# UNITED STATES PATENT AND TRADEMARK OFFICE

APPLICATION NO.	FILING DATE	FIRST NAMED INVENTOR	ATTORNEY DOCKET NO.	CONFIRMATION NO.
10/706,894	11/13/2003	Iulia Rusu	IR-2389 (2-3731)	7760

## Office Action Summary

EXHIBIT A

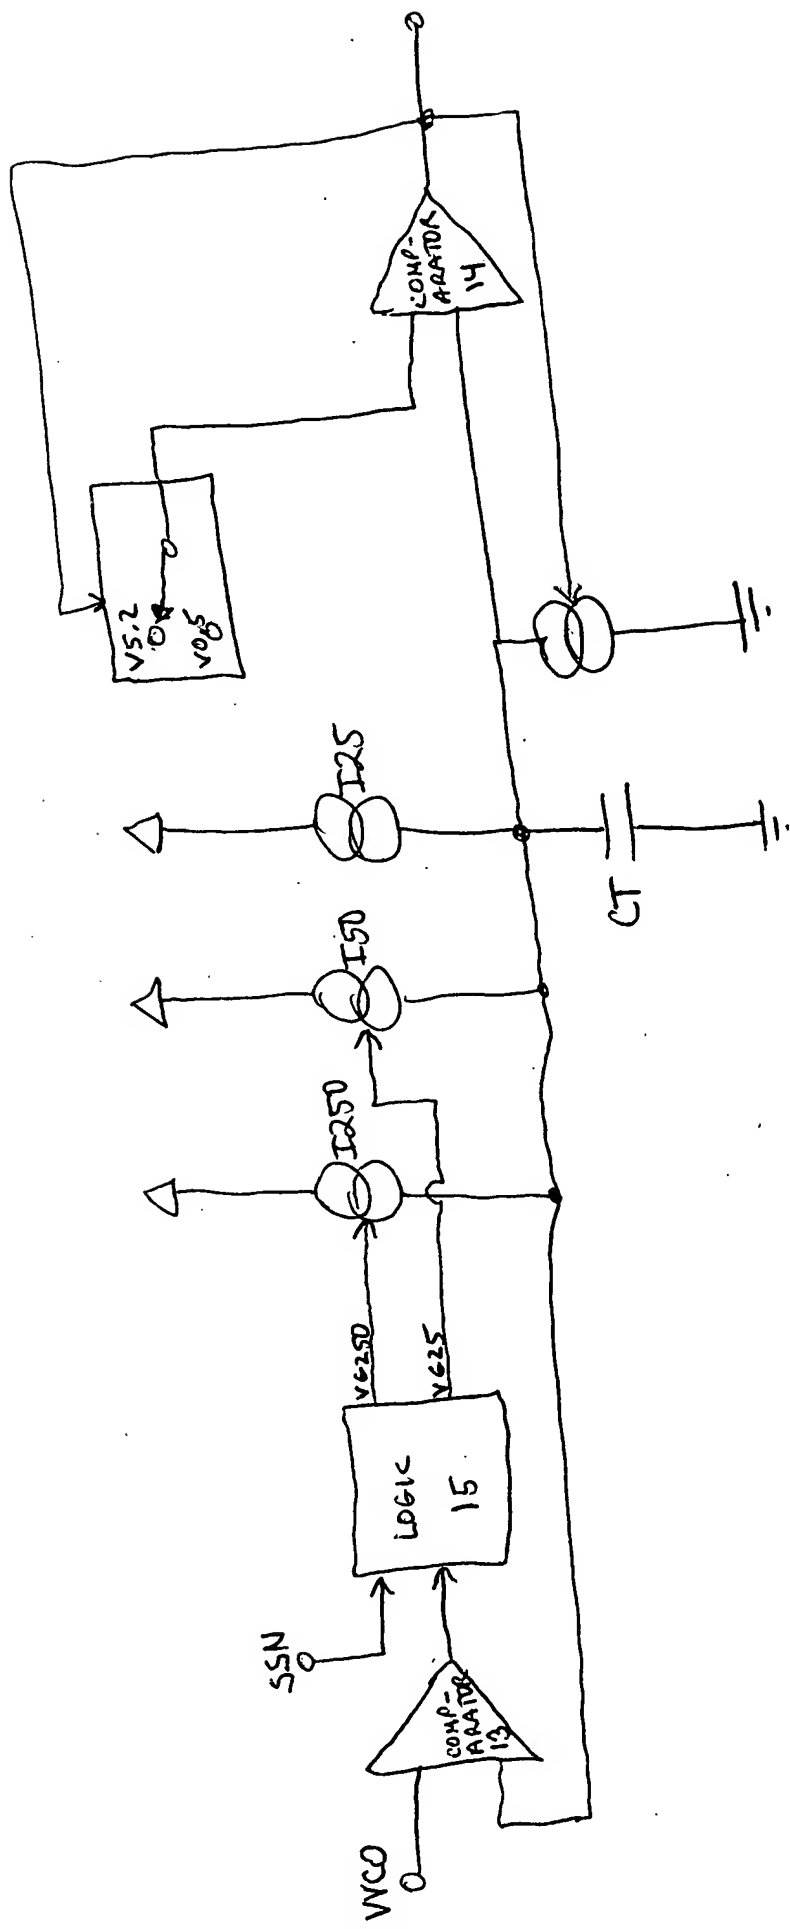
2. Exhibit A is a suggested drawing figure. A simplified circuit diagram similar to this is suggested.
